DESIGN AND ACCESS STATEMENT
NON-MATERIAL AMENDMENT
PHASE I CIRCULATION CORE
SEPTEMBER 2015

FORBURY PLACE

Job	FORBURY PLACE PHASE I & II		Job Number	20918	
Document Title	D.A.S FOR NON-MATERIAL AMENDMENT TO PHASE 1 CIRCULATION CORE		Document Number	20918-01-RP-00-133	
Prepared for	Reading Borough Council		Distribution		
Revision	Date 22/09/15		Prepared by	Checked by	Approved by
A B C		Name	RS	CG	LS
		Signature

*Proposed basement core layout, as part of discharge of condition 15.
[Extract of drawing 20918-01-AR-07-137B]
Not to scale*

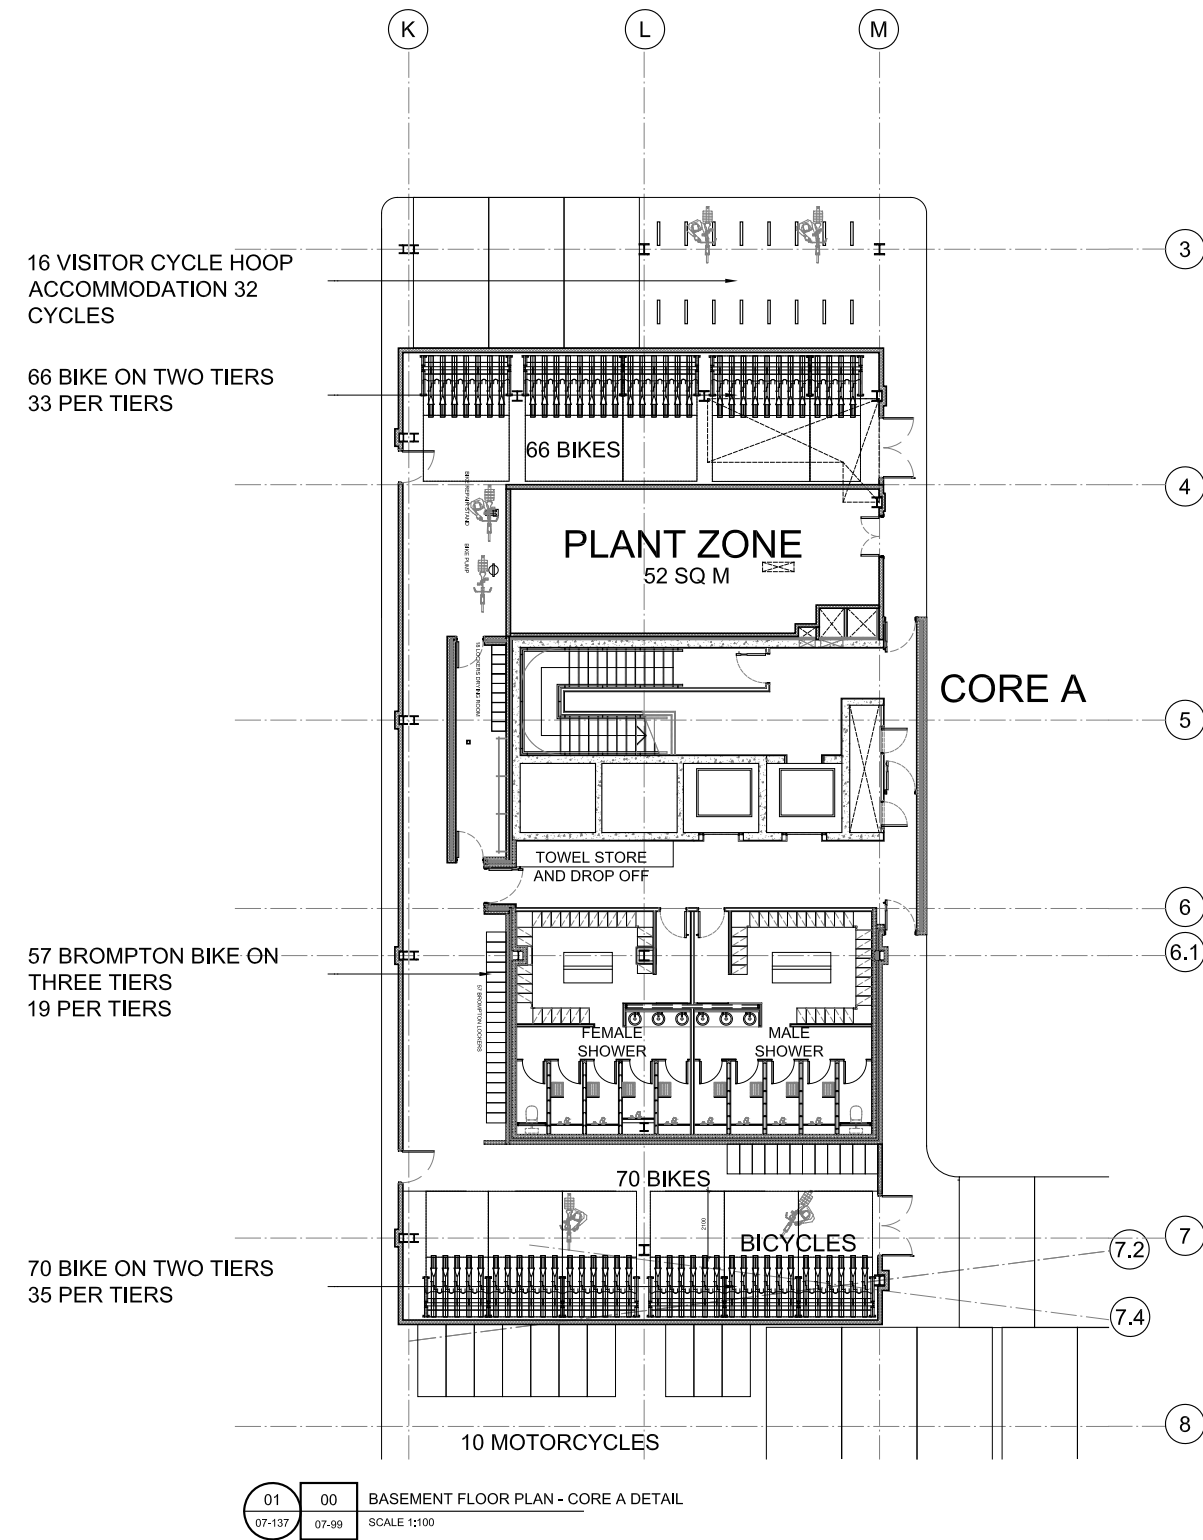
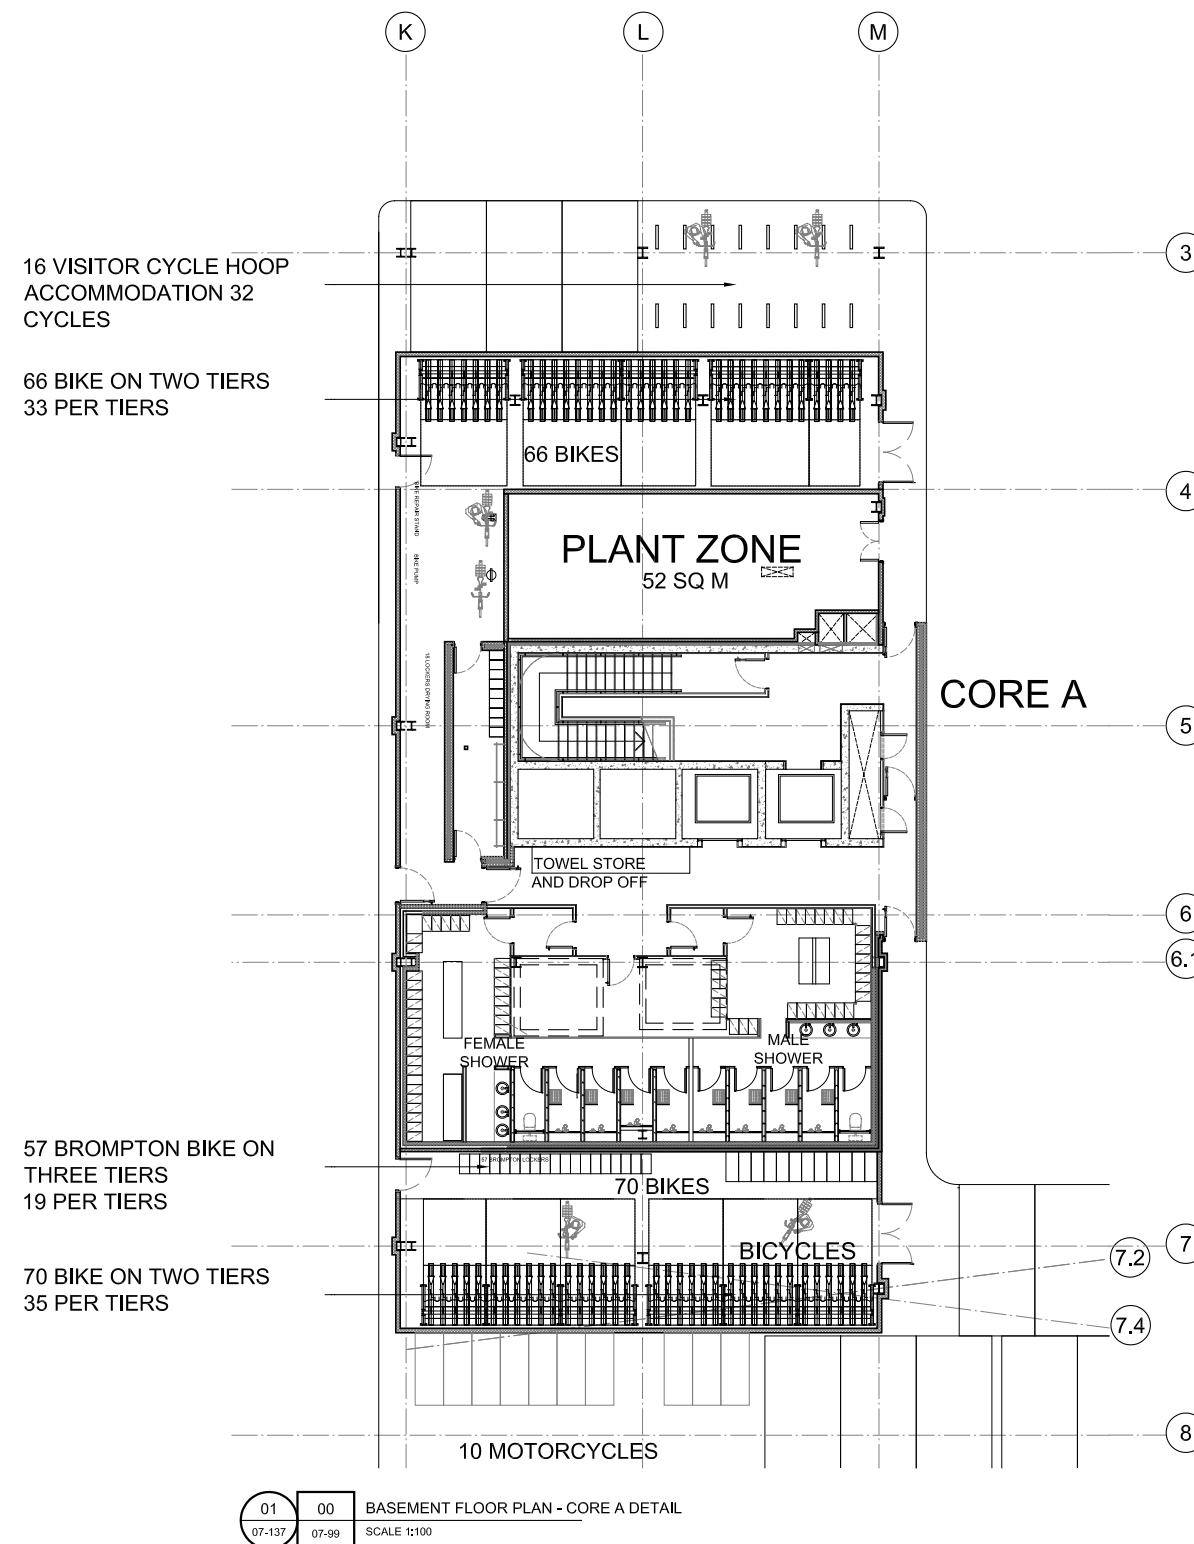
The two new lifts to Phase I Core A (West) do not serve the basement, however new lift pits will require a change in the internal spatial layout of cycle and changing room facilities.

This rearrangement is incorporated within the existing GEA of the core. With the overall principal layout of the changing and cycle facilities remains similar.

The cycle provision, including lockers is still maintained as per the discharged condition 15.

non-material amendment to Phase I Core A - Typical Floor
[Extract of drawing 20918-01-AR-07-102A]
Not to scale

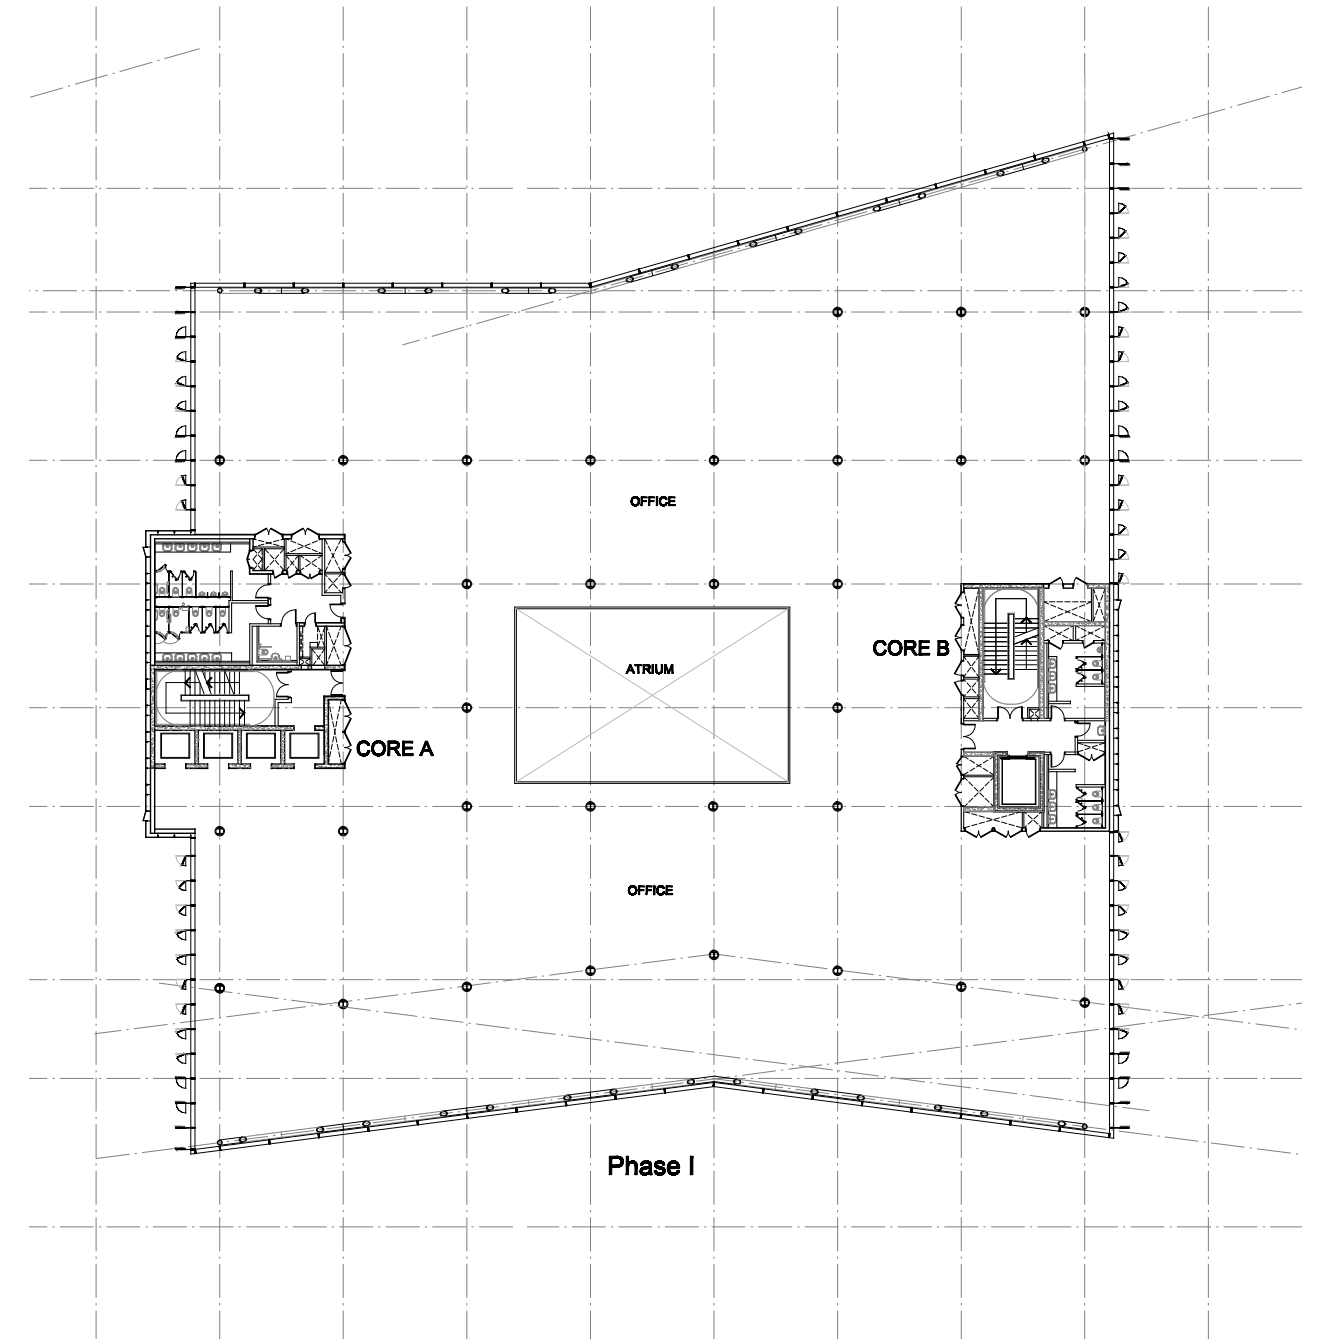
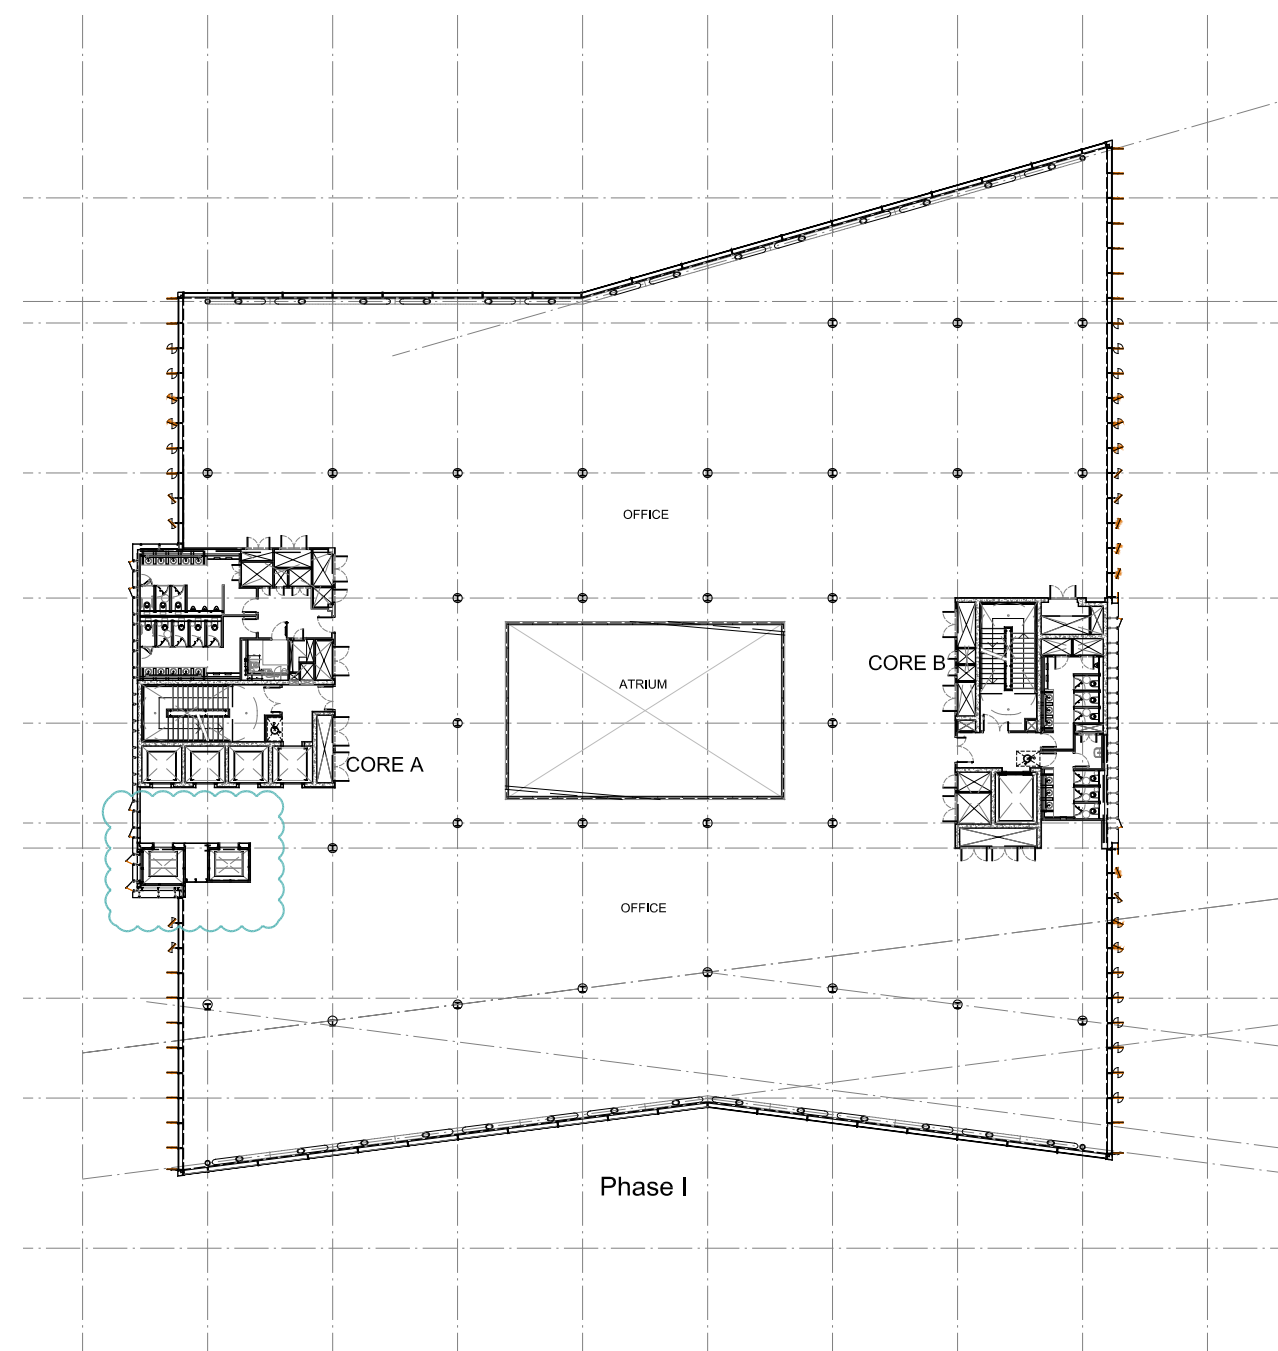
The two new lifts to Core A (West) of the Phase I building continue from ground floor up to the 6th floor. The two lifts aren't required to serve basement or 7th floors, which means that the roof is untouched and there is no lift overrun above roof level, as the overrun is terminated within level 7. The result of this change is a minor increase in GEA from ground floor up to 7th floor.

Both lifts are grouped together with the existing lifts to the building. The external treatment to the core, with its feature 'peel' cladding continues south to enclose the proposed lift that sits outside the existing external envelope and maintains the current corner treatment.

*The proposed NMA to western core of Phase I
looking East along Forbury Road*

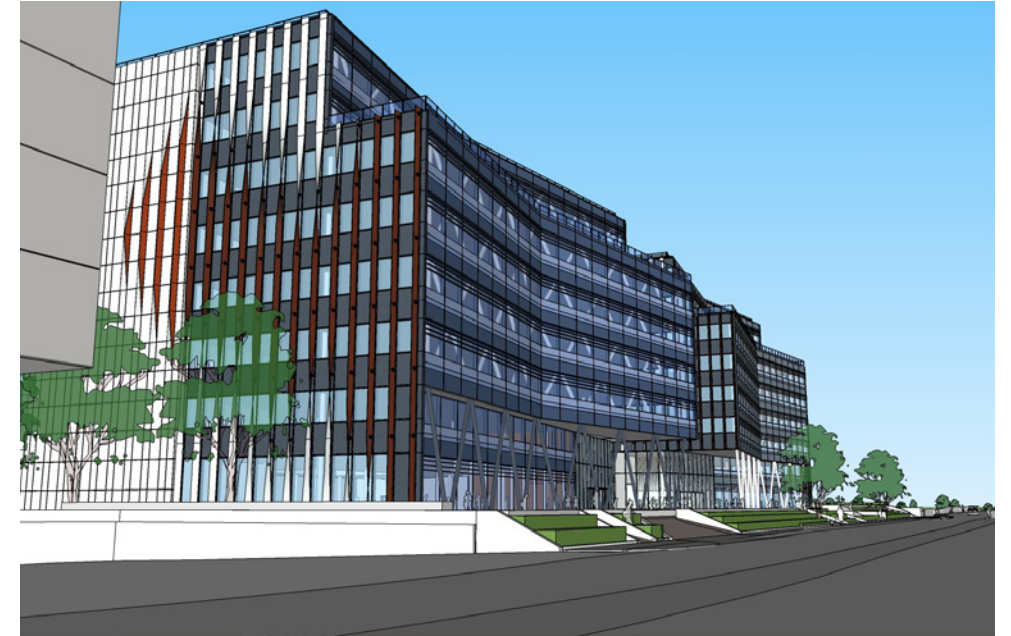
The external treatment to the core extends southward to enclose the proposed lift that sits outside the external envelope.

The feature 'peel' cladding to the core is continued southwards to replace the area of twisted fins and the current corner treatment is relocated to suit. This maintains the overall dynamic twisting affect across the facade as one moves past the building and doesn't change the concept principles of the building.

This update results in a change to the West elevation only, as the South elevation is unaffected by the continuation of the core.
